CONDUCT OF LATEST **MONITORING** AND

INSPECTION OF THE VICTORIA-AMNAY ROAD CONSTRUCTION PROJECT OF THE DEPARTMENT OF

PUBLIC WORKS AND HIGHWAY (DPWH)

CONDUCT OF LATEST MONITORING AND INSPECTION

STARTING POINT OF PHASE 8 PROJECT

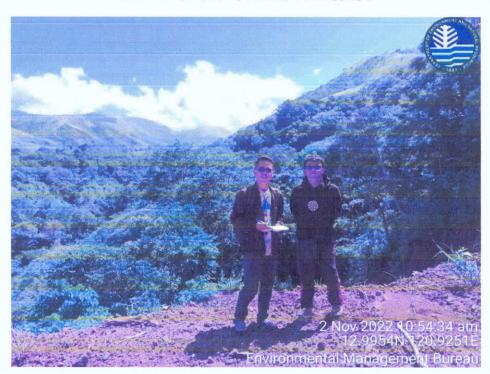
- 4. The phase 8 project has already opened its approximately 500 meters in length along the total length of 8.1 km, it lies between geo-coordinates 12.9936 N, 120.9212 E as starting point and 12.9954 N, 120.9251 E as ending point as to date.

BOX'CULVERT, DRAINAGE CANAL, AND SOME SLOPE PROTECTION COLLAPSED

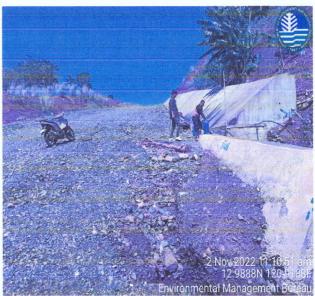
- 5. Some slope protection has already been applied. However, mostly of the project with steep slope has no slope protection which is vulnerable to landslide.

- 6. All portion of new opened road with steep slope was eroded.
- 7. Some box culvert and drainage canal were collapsed.
- 8. No records of submission of rehabilitation plan including slope protection measures on site.

- 1. Letter may be sent to the project proponent advising and reiterating them to immediately prioritize the implementation and rehabilitation of critical slopes in accordance with Environmental Management Plan (EMP).
- 2. It is also recommended that geohazard risk assessment by MGB be undertaken.
- 3. Submission of their effective rehabilitation plan.
